Hetch Hetchy Communication System Upgrade Project

Finding of No Significant Impact,
Assessment of Actions Having an Effect on Cultural Resources,
Tuolumne Wild and Scenic River Section 7 Determination,
Errata Sheets, and
Public Comment and Response Report

April 2008

- 7) Page 3-175, and Page 4-4, first paragraph of Mitigation Measure 2 – Human Remains:

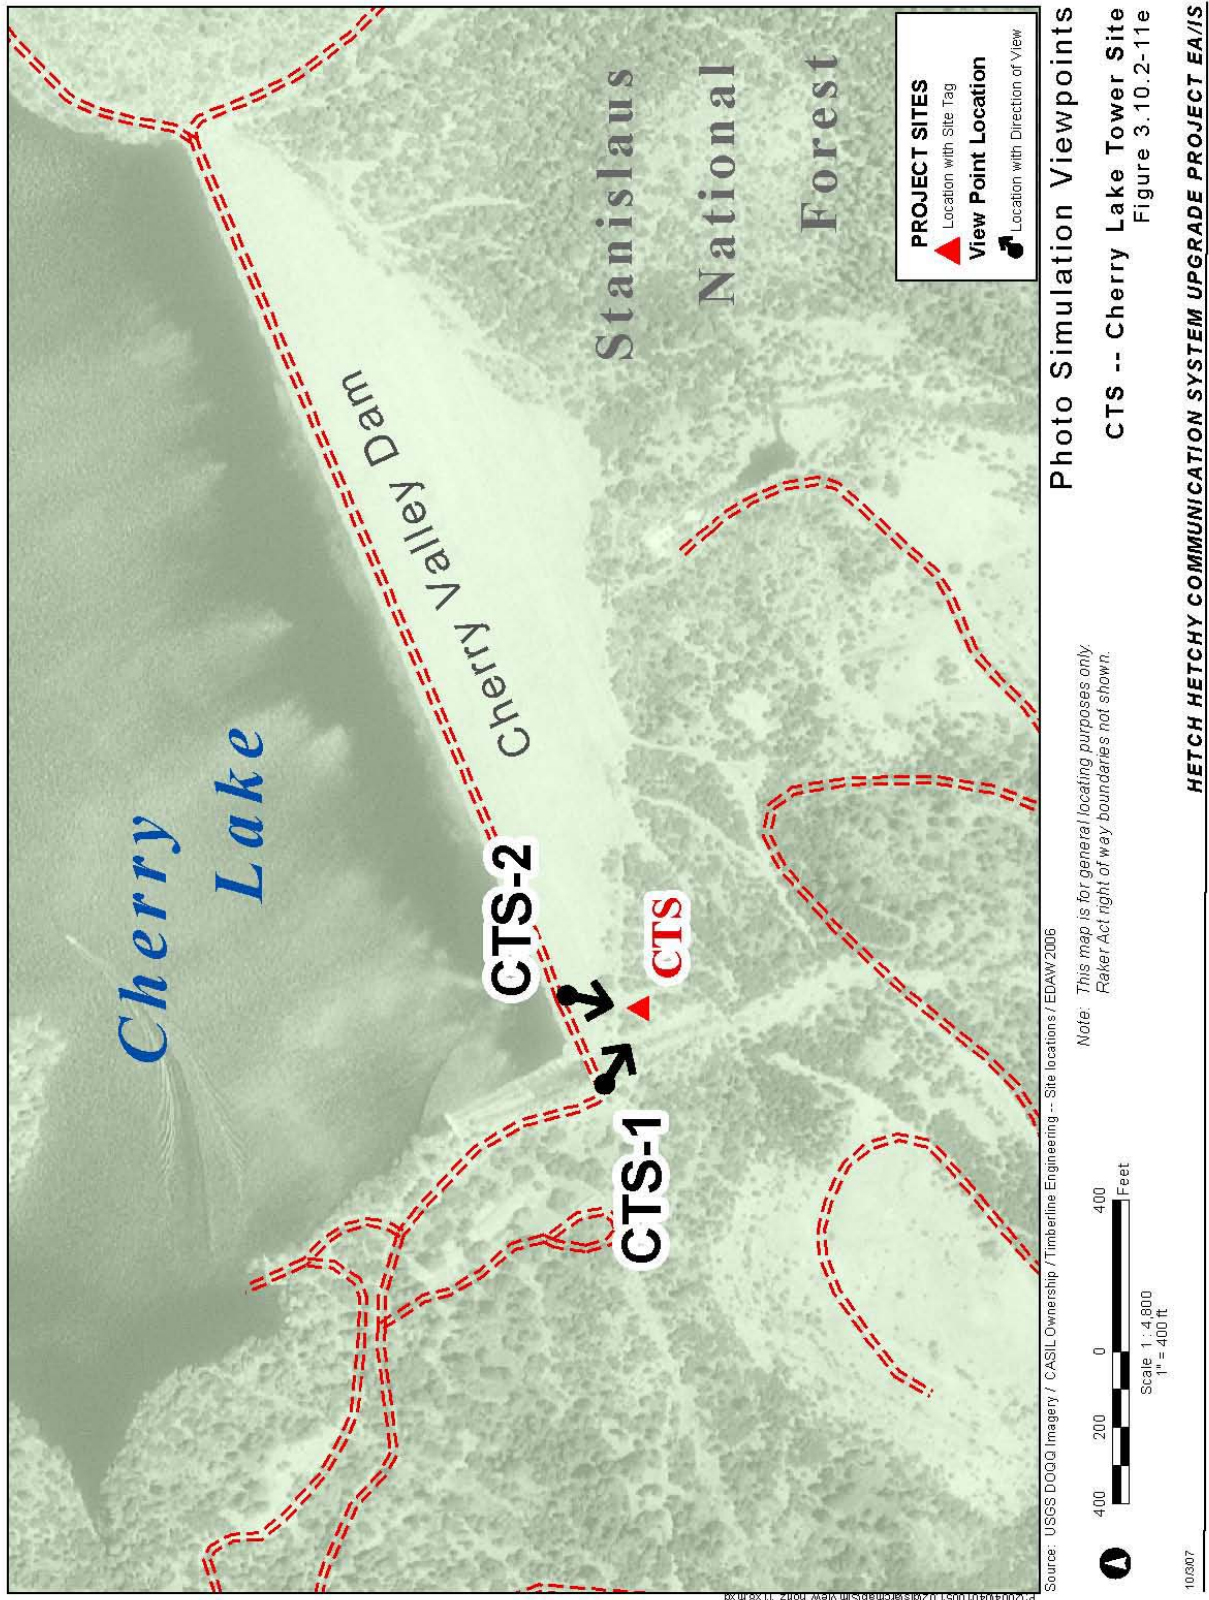
Mitigation Measure 2 – Human Remains: ~~The following mitigation measure is required to avoid any potential adverse effect from the proposed project on uncovered human remains.~~ If human remains are encountered all project-related construction activity will halt within 50 feet of the find. If the remains are discovered on Federal lands, the provisions of Native American Graves Protection and Repatriation Act (NAGPRA) shall be adhered to and implemented by the federal agency (NPS or Forest Service).
